**KETCHIKAN AIRPORT TAXIWAY
AND APRON REHABILITATION
PROJECT NO. 67946
AIP No. 3-02-0144-022-2013**

Project As-Built Drawings have been reviewed by the Project Engineer and represent to the best of my knowledge, the project as constructed.

INDEX *Asbuilts*

CERTIFIED TRUE & CORRECT AS-BUILT OF ACTUAL FIELD CONDITION:
Paul E. Nye DATE 5/12/15
CONSTRUCTION PROJECT MANAGER

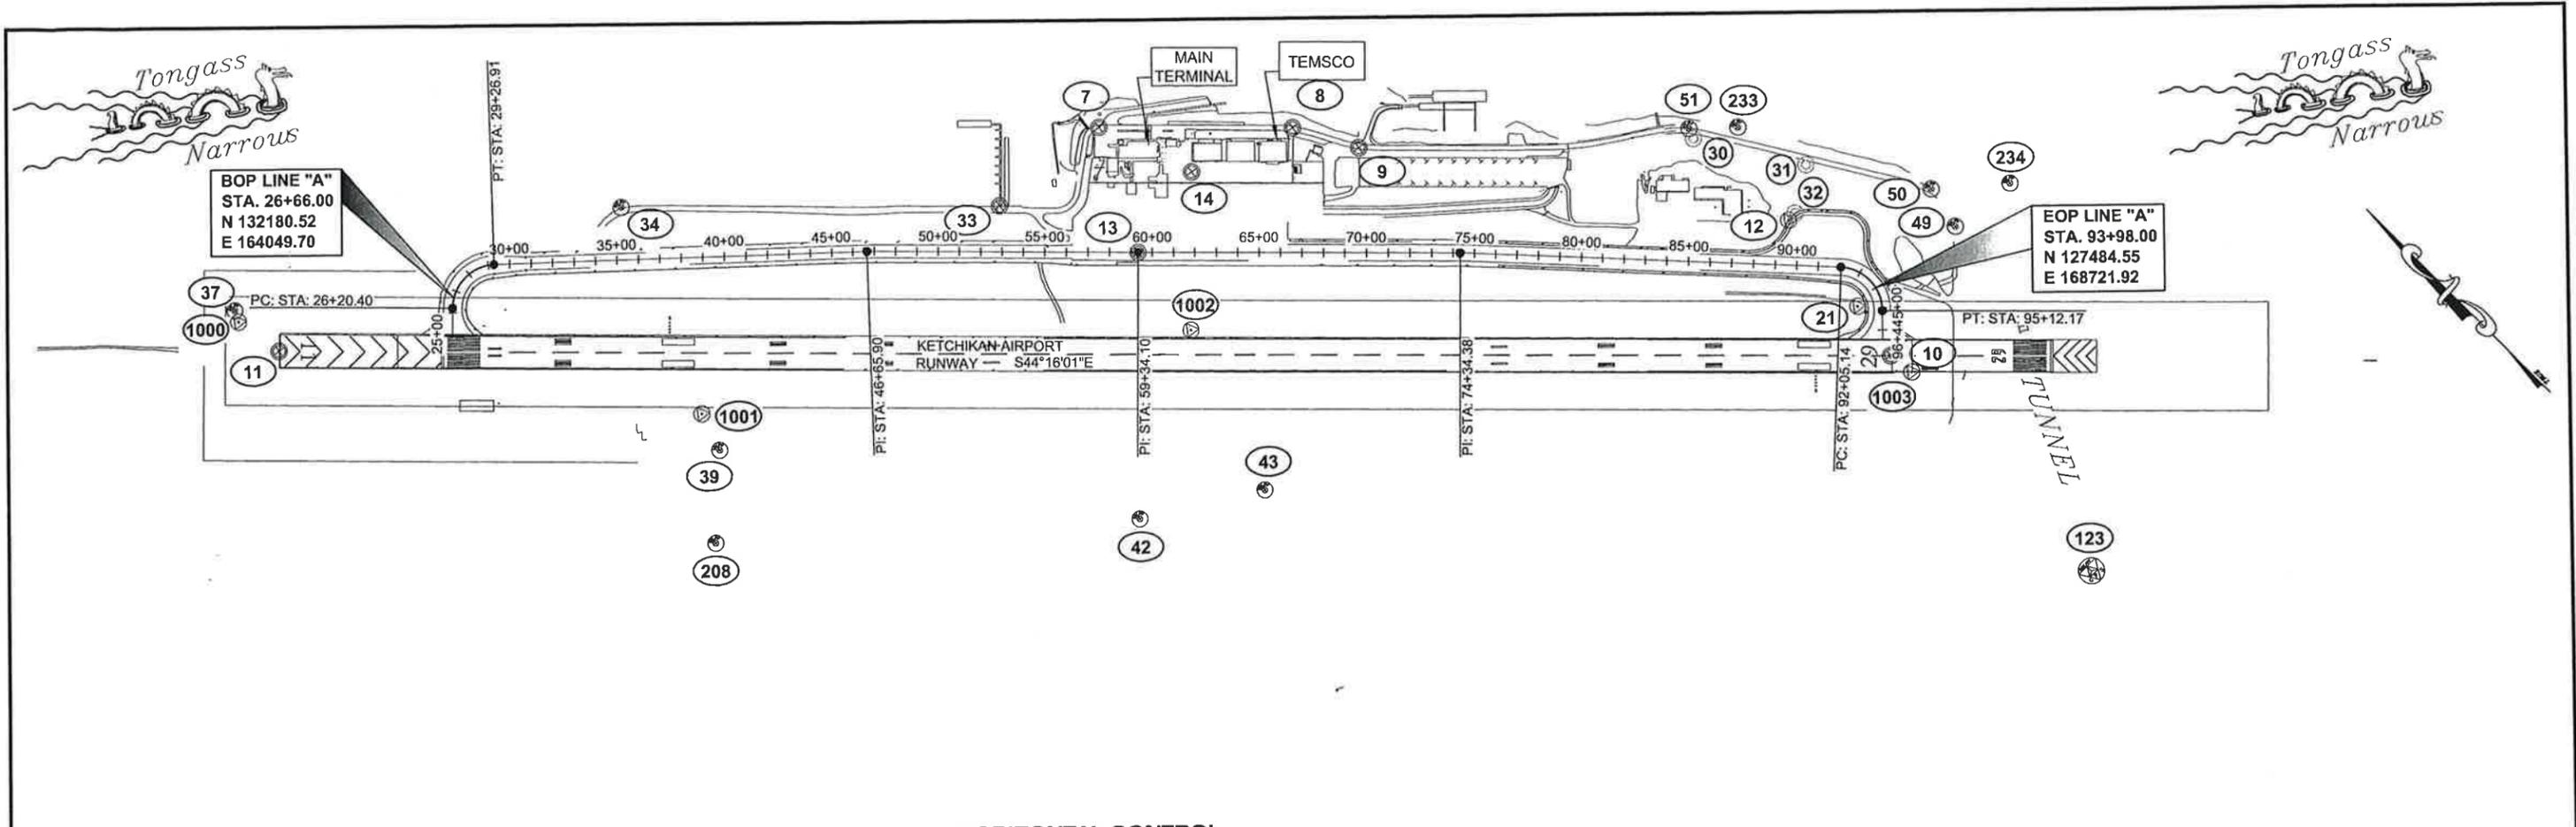
monument notes:
 #10 - Needs to be adjusted. Asphalt around monument is cut monument under existing runway overlay.
 #21 - concrete pad in place, No monument.
 #32 - Destroyed
 #12 - Could not locate

TAXIWAY 'B' TYPICAL SECTION - EXISTING

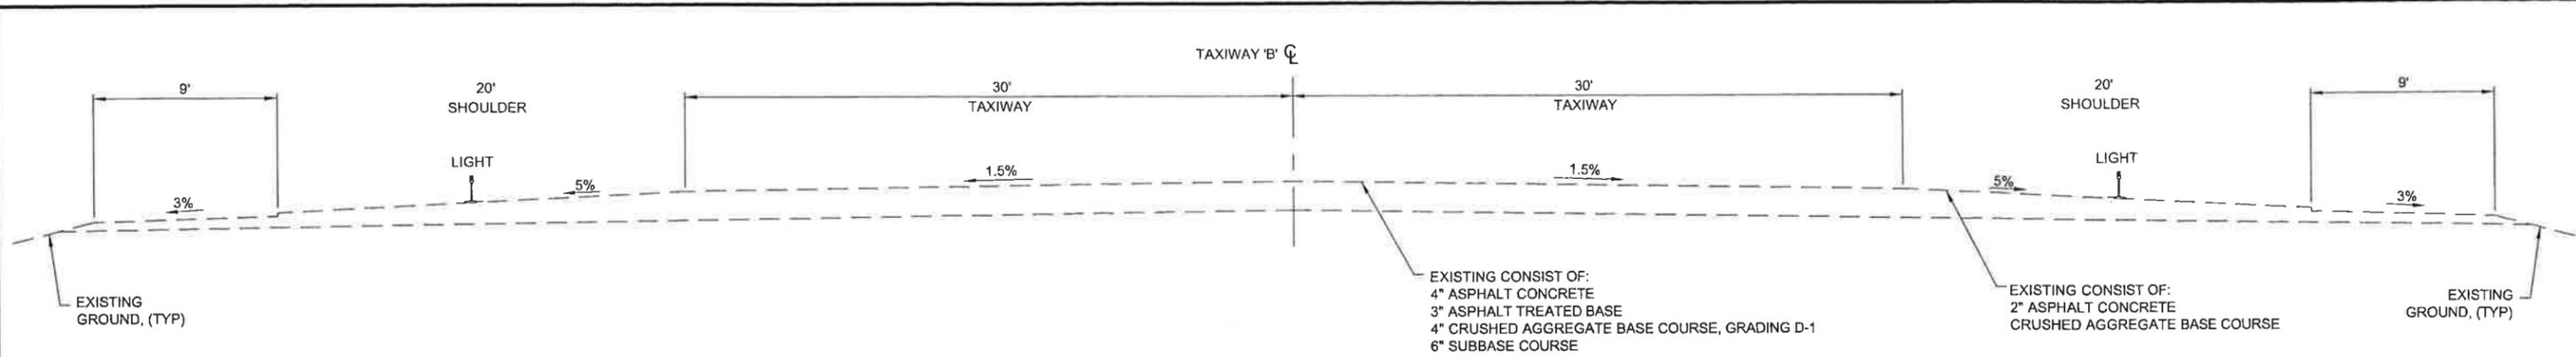
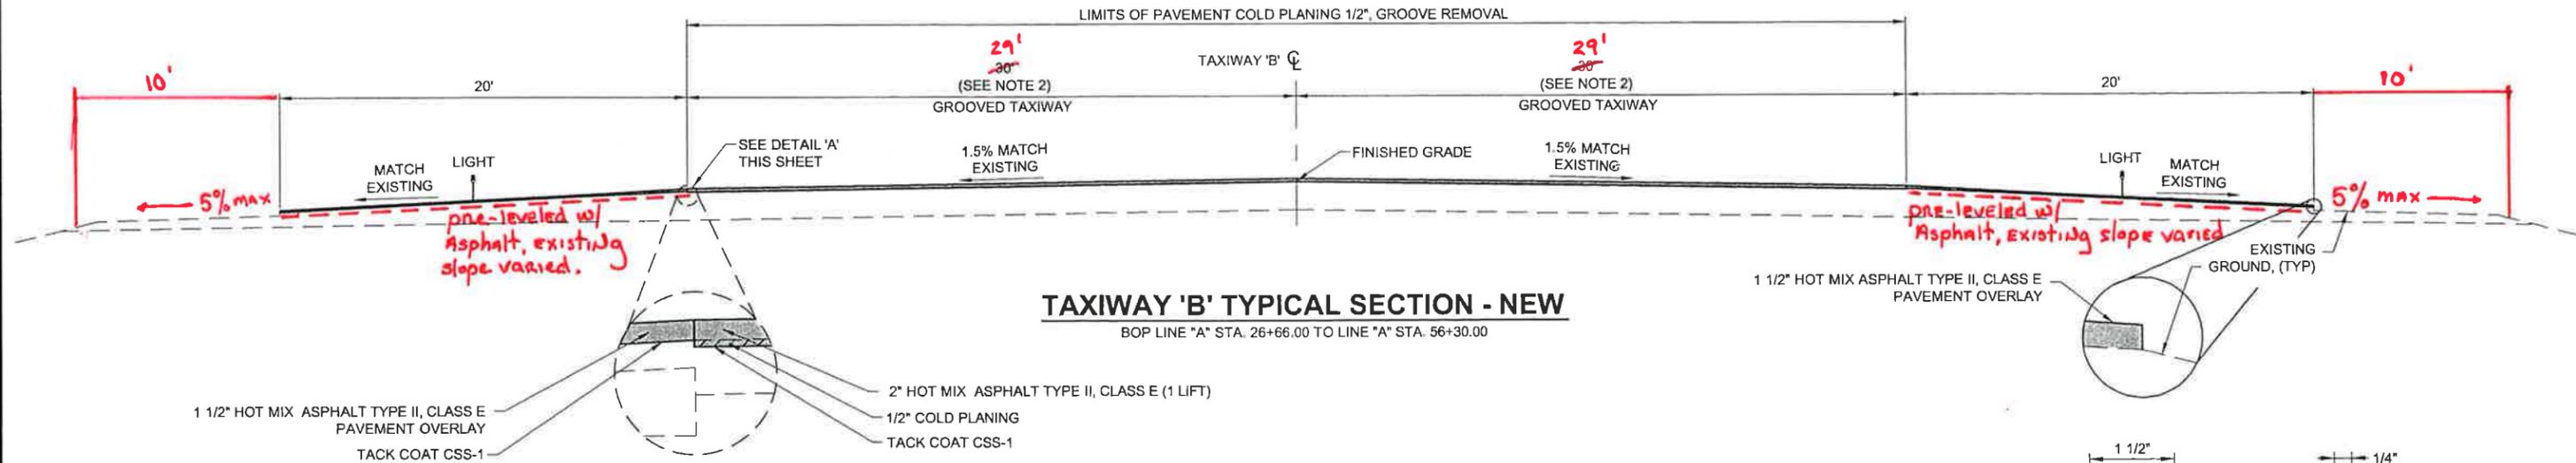
1. NEW TAXIWAY 'A' & 'B' PAVEMENT WILL BE GROOVED, THE GROOVES WILL RUN PERPENDICULAR TO CENTERLINE.
2. SEE SECTION P-630 OF THE CONSTRUCTION SPECIFICATIONS FOR DETAILS OF THE GROOVING OPERATION.
3. Built 5% shoulders and 3:1 slopes with Recycled Asphalt Material - RAM, existing ground varied.

MAIN APRON PLAN VIEW

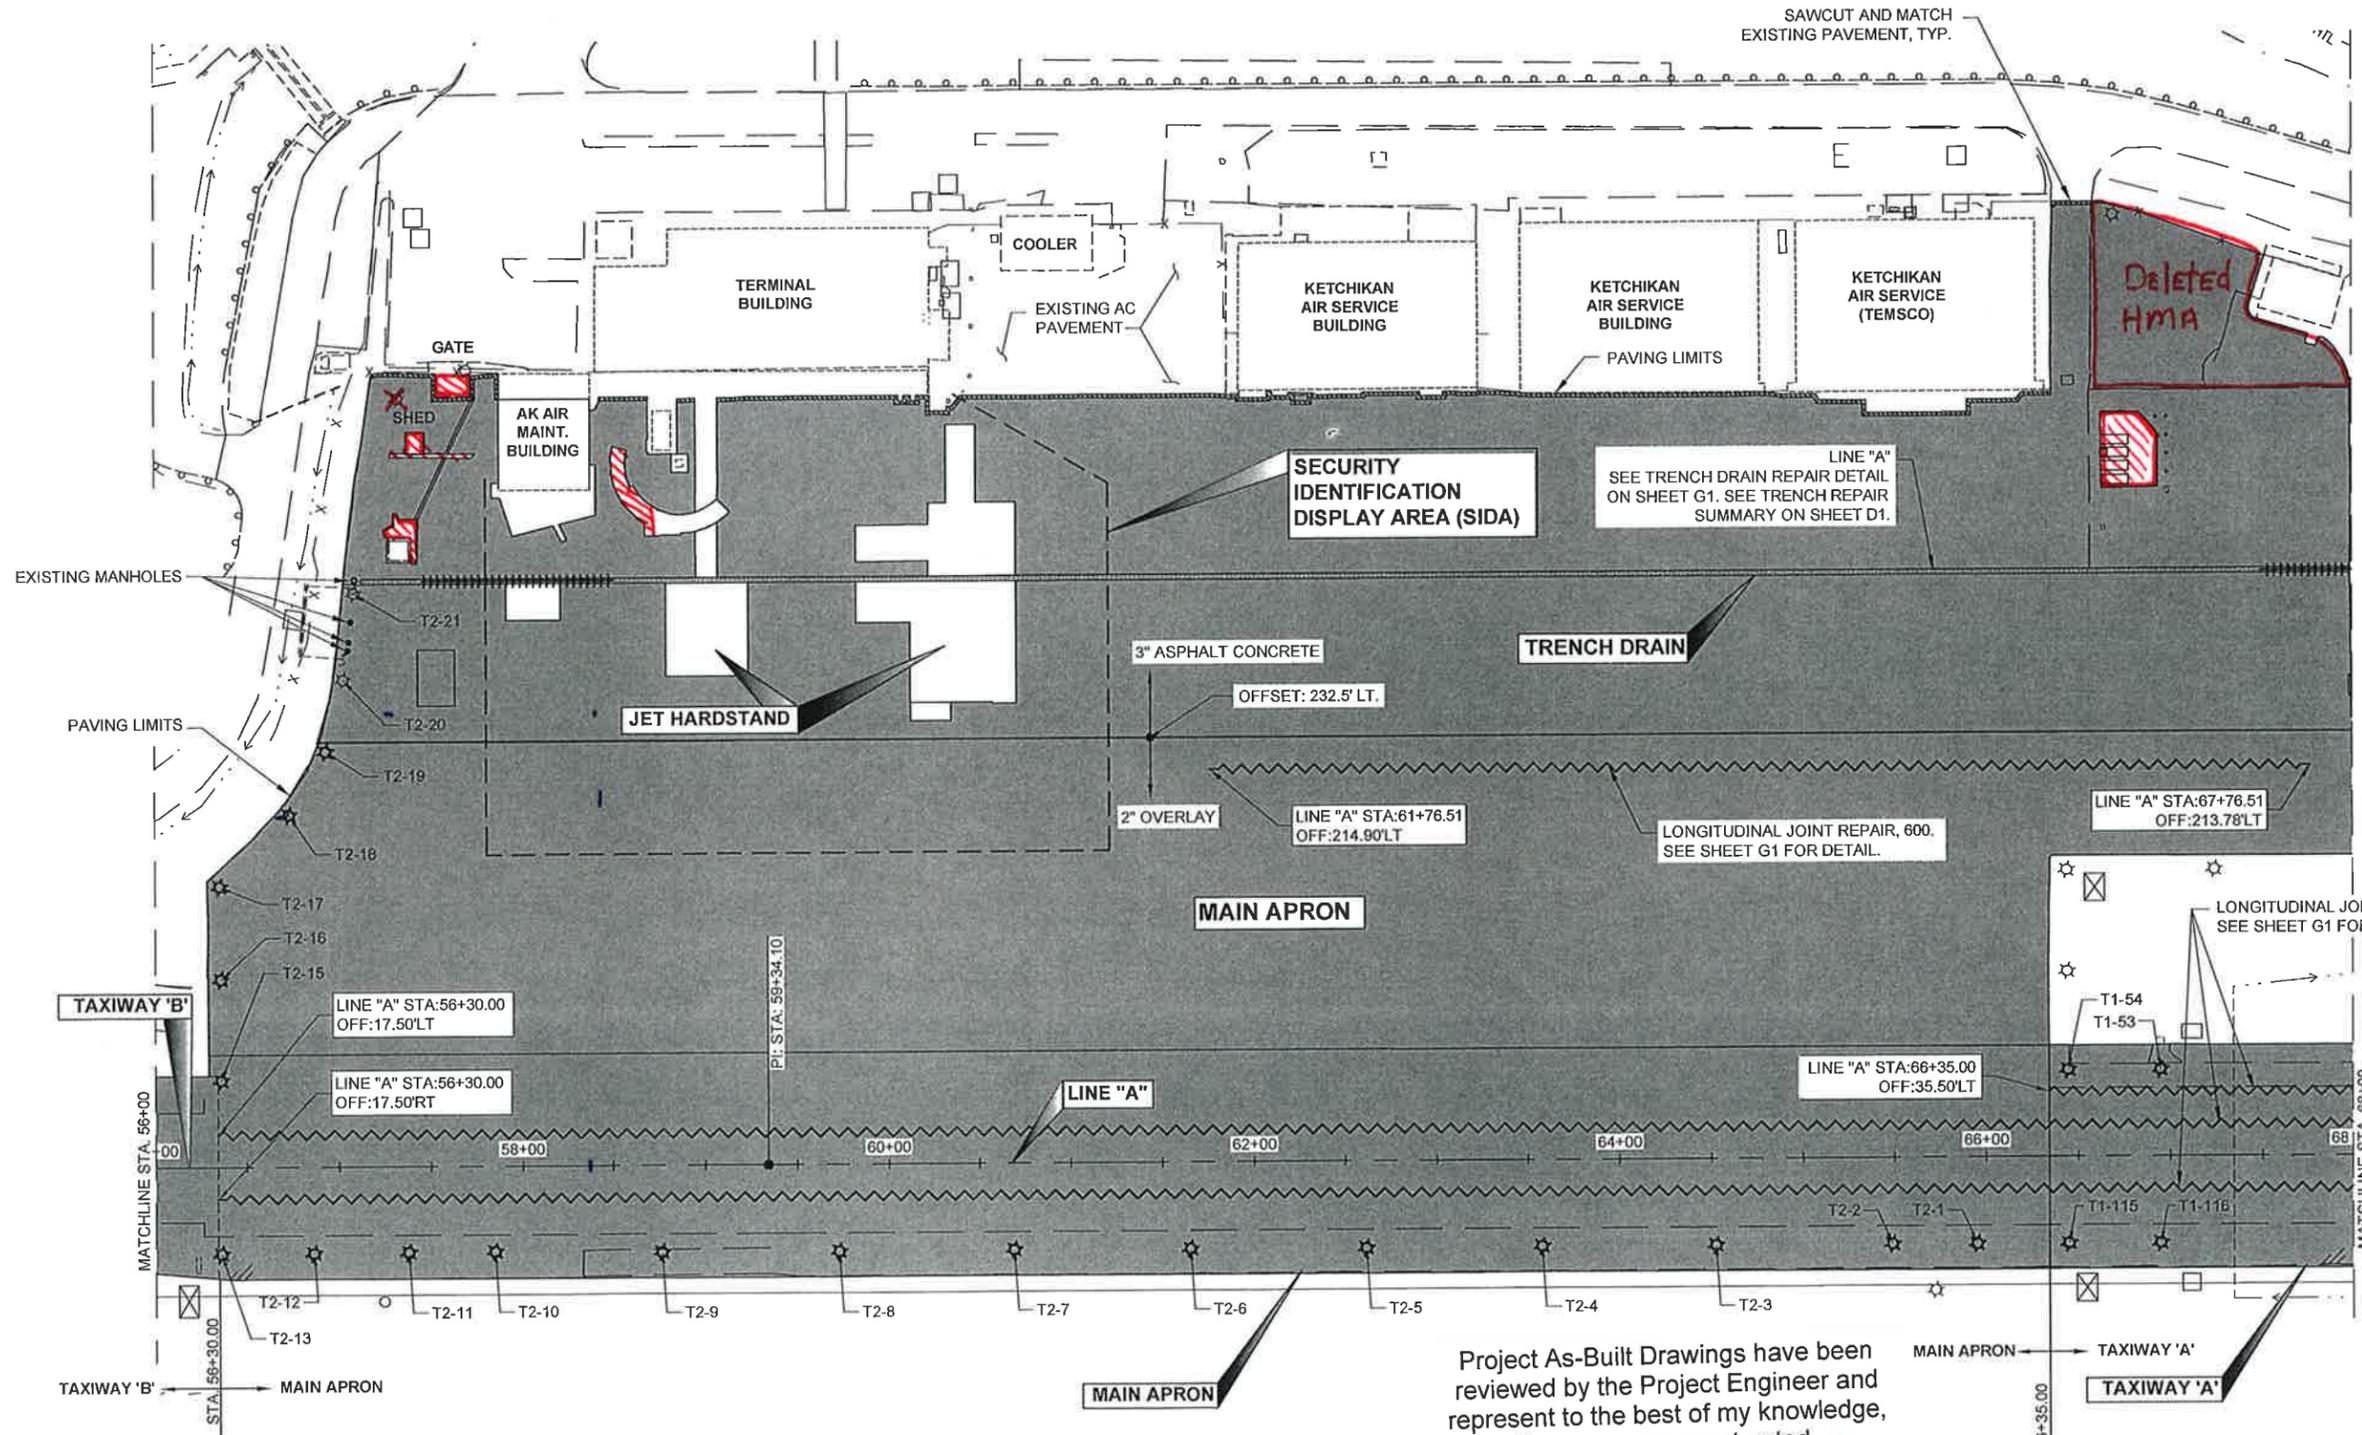
**Removed Existing-2" HMA Overlay**

DRAWN	DATE	KETCHIKAN A.P.
S. McCard	4/30/14	SIDA AREA
APPROVED	DATE	STRIPING ASBUILTS
		DETAIL
SCALE	SHEET	PROJECT NO.

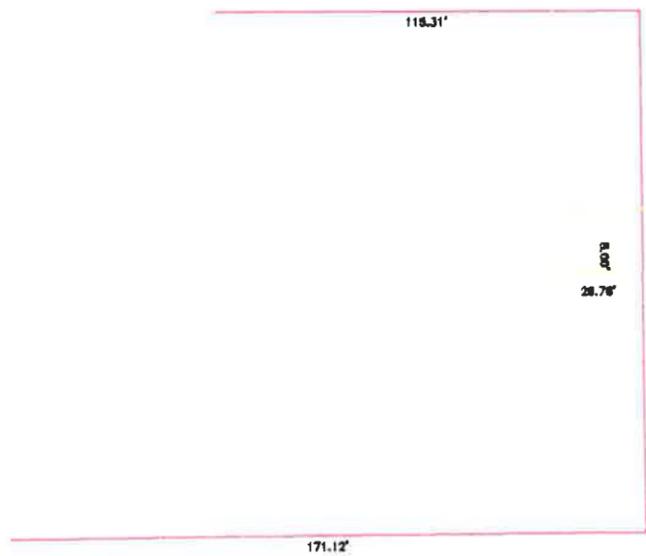
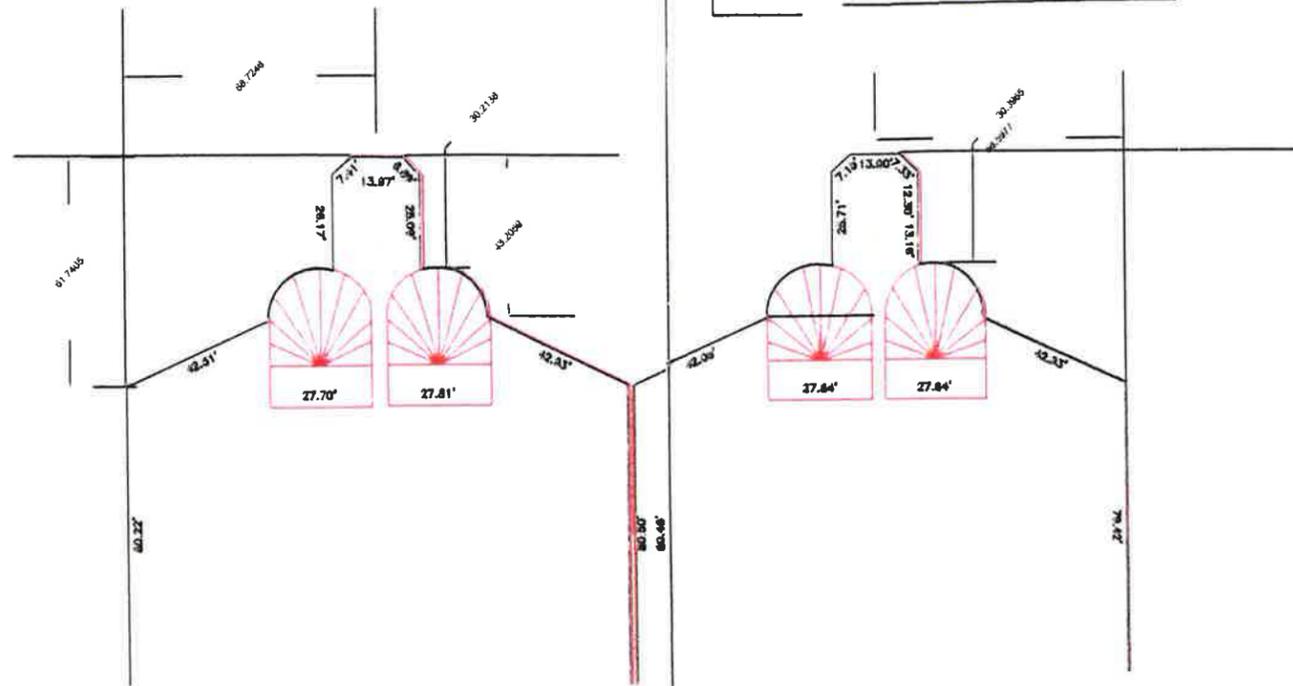
Jetway "A"

Jetway "B"
